May 18, 2015

TO: All U.S. Ford and Lincoln Dealers

SUBJECT: **Customer Satisfaction Program 15B04**
Certain 2013 and 2014 Model Year C-MAX Hybrid Electric Vehicles (HEV)
12 Volt Battery Test and Module Software Update

FIGURE 1

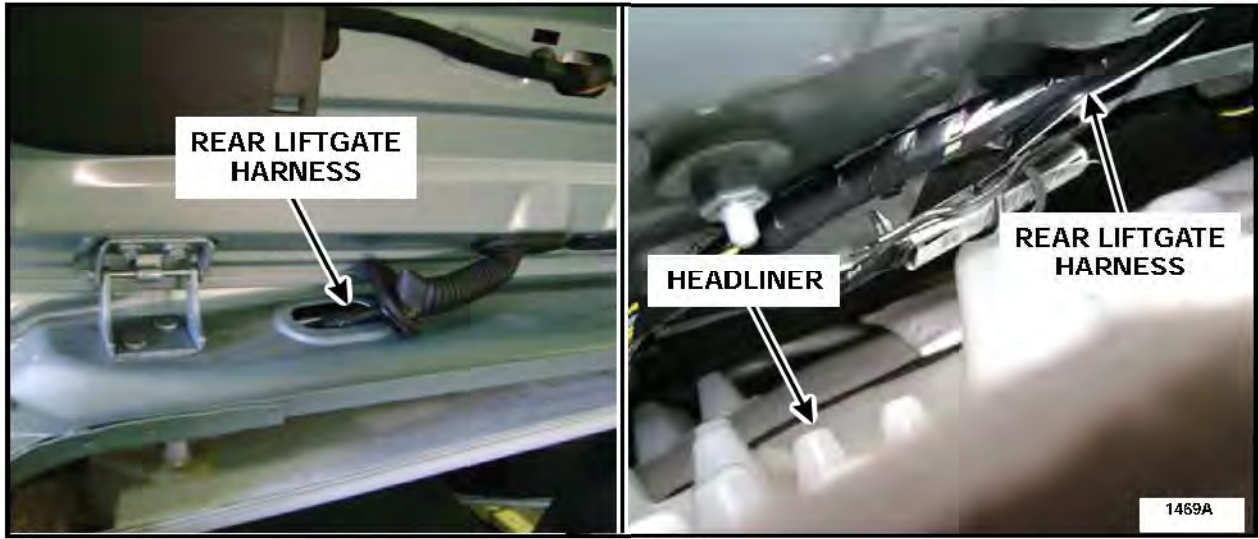
1. Inspect for damage or chafing to wiring harnesses in the areas noted below. See Figures 1 through 3 for locations, and Figure 4 for examples of damage and chafing.

- Rear Liftgate Harness: in the opening between the body and the rear liftgate, and under the headliner near the sheet metal opening where the harness passes through.
- On the vehicle body wiring harness near C339 and C340.

3. Wrap 3M™ Temflex™ Cotton Friction Tape or equivalent to the wiring harnesses in following areas:

- Rear Liftgate Harness: in the opening between the body and the rear liftgate, and under the headliner near the sheet metal opening where the harness passes through.
- On the vehicle body wiring harness near C339 and C340. Wrap tape on harnesses near connectors to protect against damage or chafing.

FIGURE 4

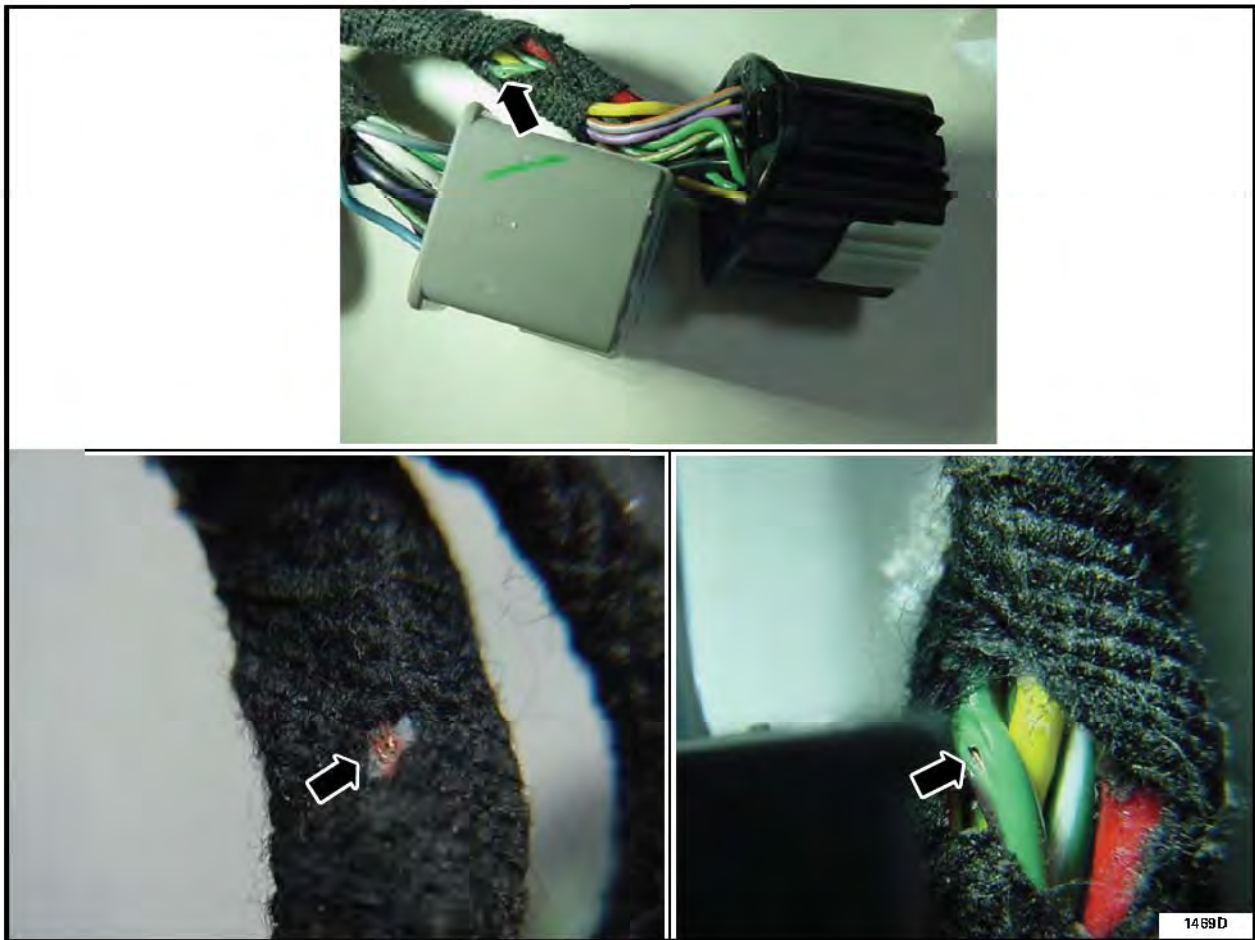
2. Is damage or chafing present?

Yes - Repair circuits as required. Refer to Wiring Diagram (WD) Section 5-1. Proceed to Step 3.
